Mimo Cotton Zone Textile Ltd.

Holding # 97, Sayatol Market, Surabari, Kashimpur, Gazipur

13th November 2018

Foundation Schedule(Set-2 Drawing)

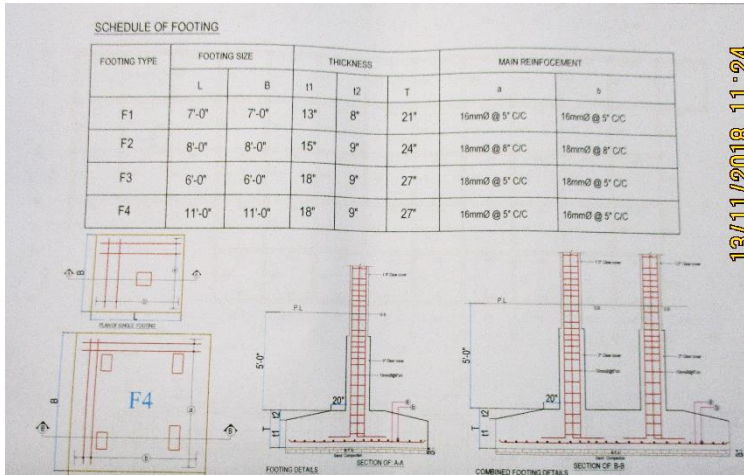
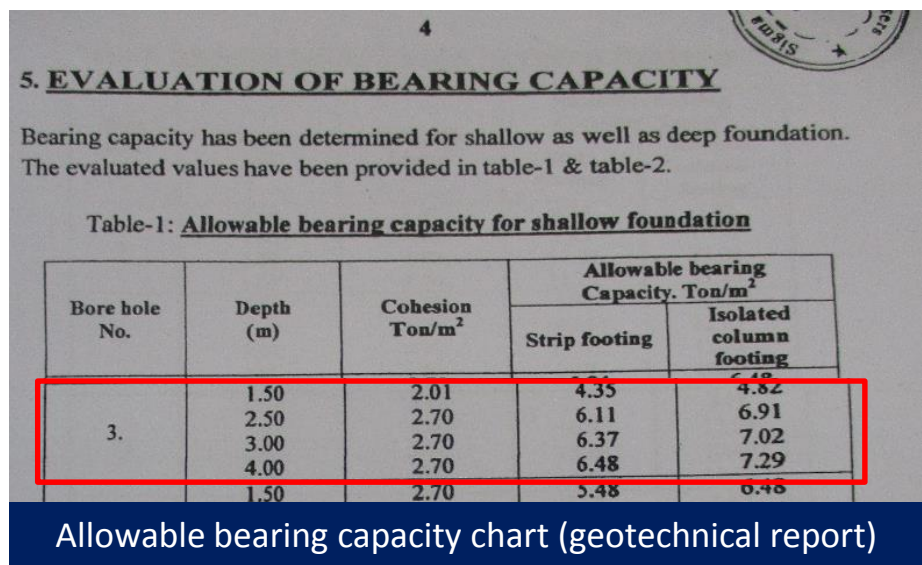
**Bearing capacity of foundation exceeds
normal design limit**

As per provided soil test report, the factor of safety for isolated footing was found to be less than 2.5 which is below the BNBC standard. Factory is required to check the adequacy of the foundation. Moreover, depth of footing is not clear because EGL level is not mentioned in the drawing and on site EGL height is found almost 2 feet down from GB at East side.

Discrepancies between provided drawing and on-site condition

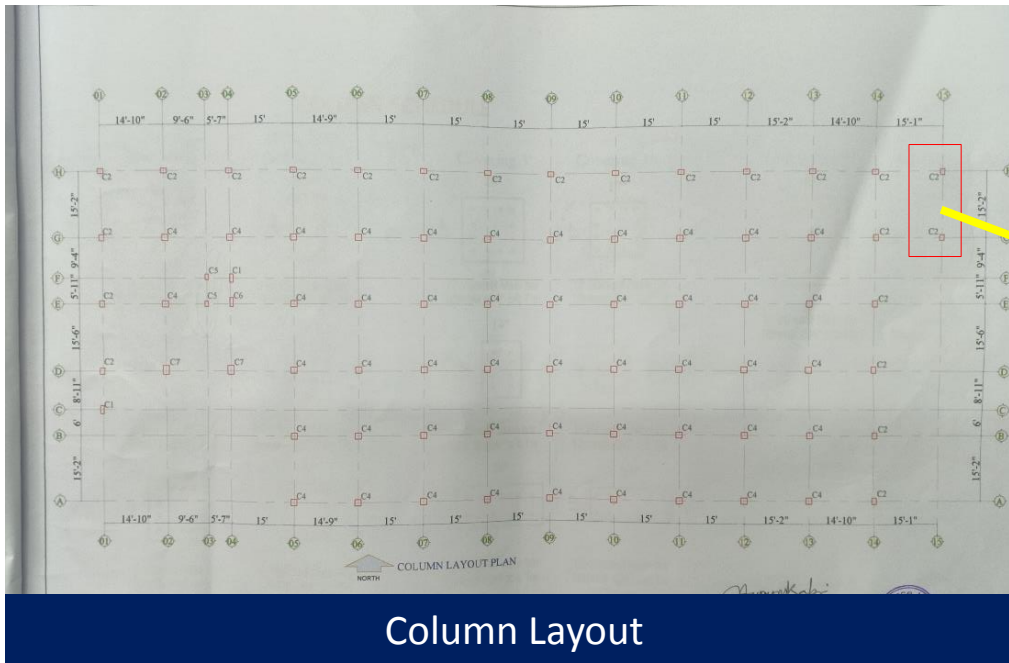
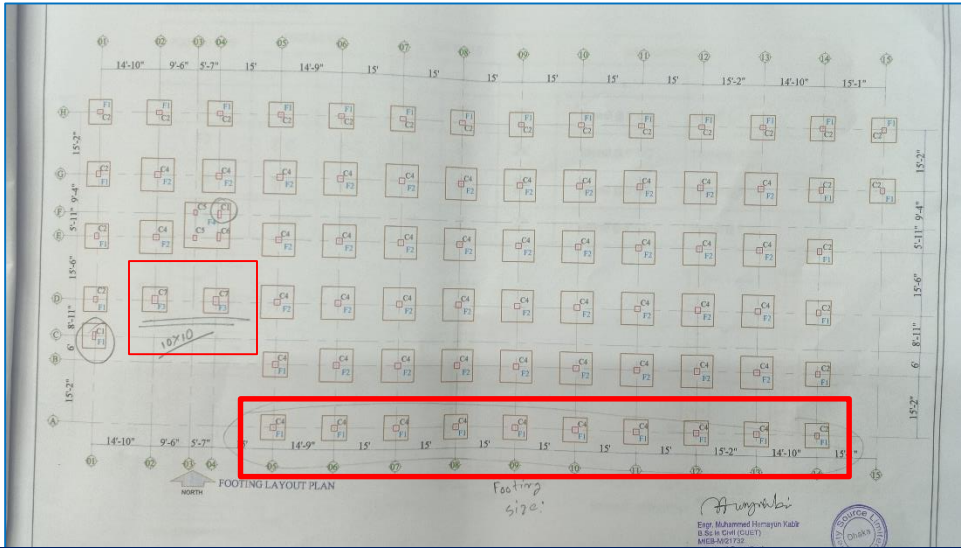
The column layout did not match with as-built structural drawing. On grid-15, two extra columns were observed on column layout in as-built structural drawing which were not found on site.
Separate steel structural was found on that grid.

Footings Schedule of as-built drawings

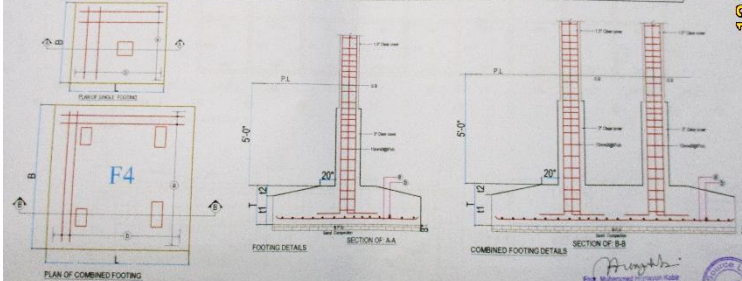
Footings sizes are found different in construction drawings and as-built drawings. Red marked footing sizes are found less on as-built drawings than the construction drawings. Factory engineer is required to check the actual size of the footing and revised the as-built drawings accordingly.

Exposed rebar at roof

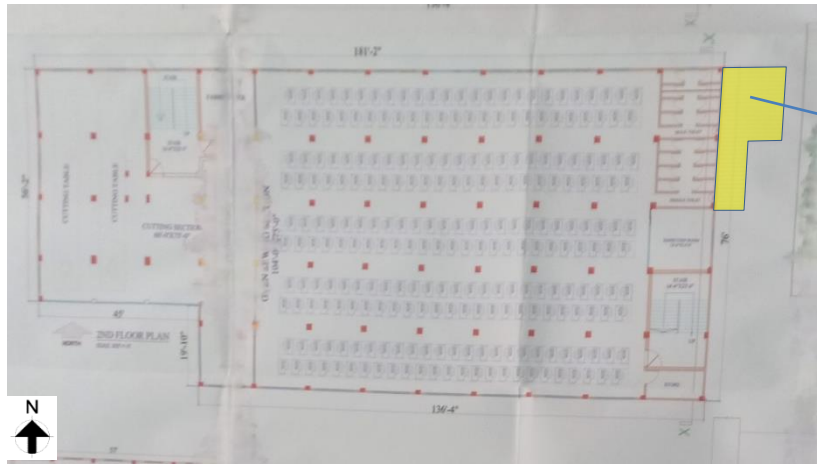
All exposed reinforcement to be protected from corrosion. Currently the exposed reinforcement is prone to corrosion.

Floor layout plan of factory building

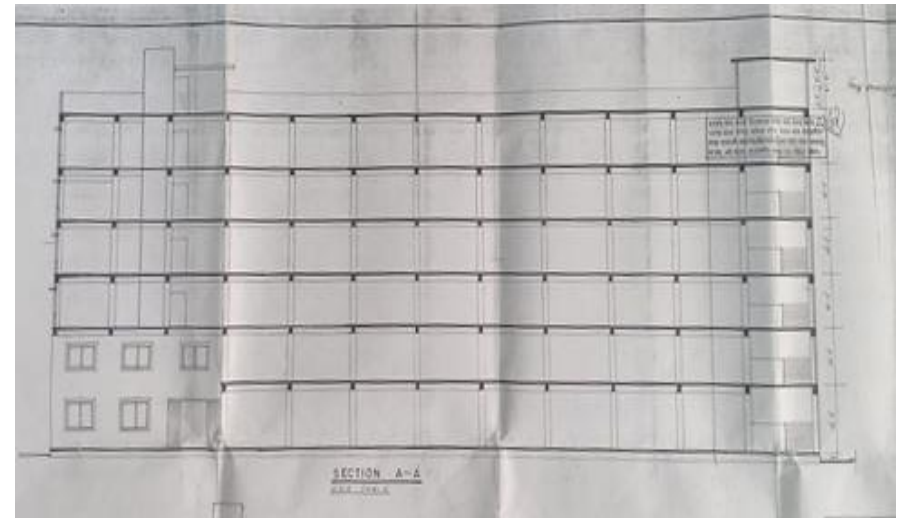
At east side of factory building, a two storied steel structure was found which not structurally connected with factory building. Structural and architectural drawings were not available for the two storied structure.
